Proposal for amendments to ECE/TRANS/WP.29/2024/34

Proposal for a draft guidance document on Artificial Intelligence in the context of road vehicles

Figure 1: Example scheme

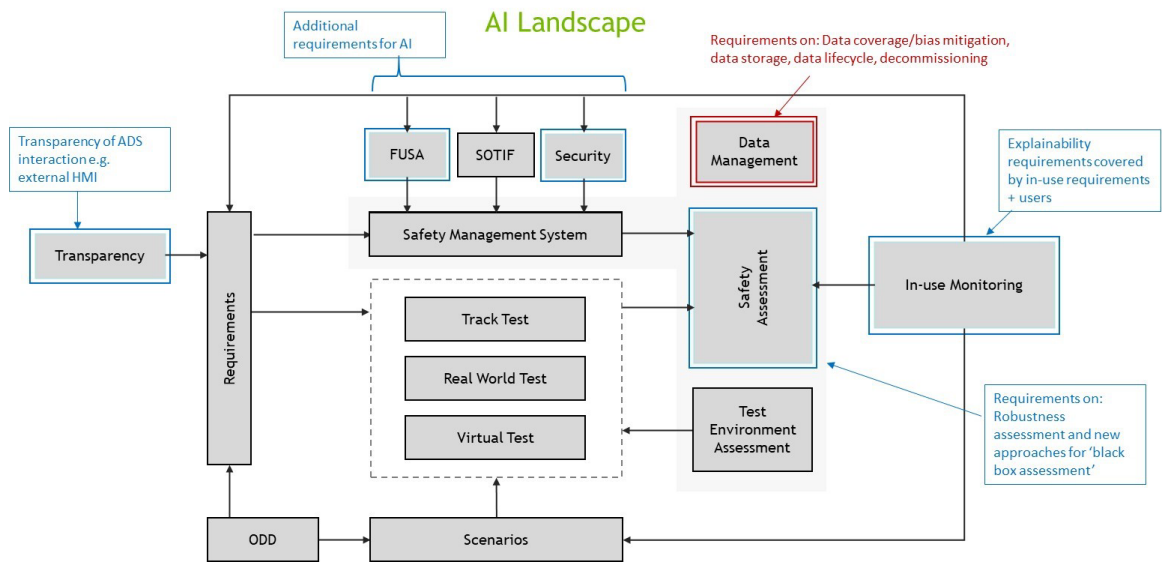
Alternative:

The figure below provides a schematic overview of the New Assessment/Test Method for Automated Driving (NATM) including the interaction of the individual pillars, scenarios, safety requirements of highly complex systems such as those used in automated driving and showing the possibility to address AI specificities.
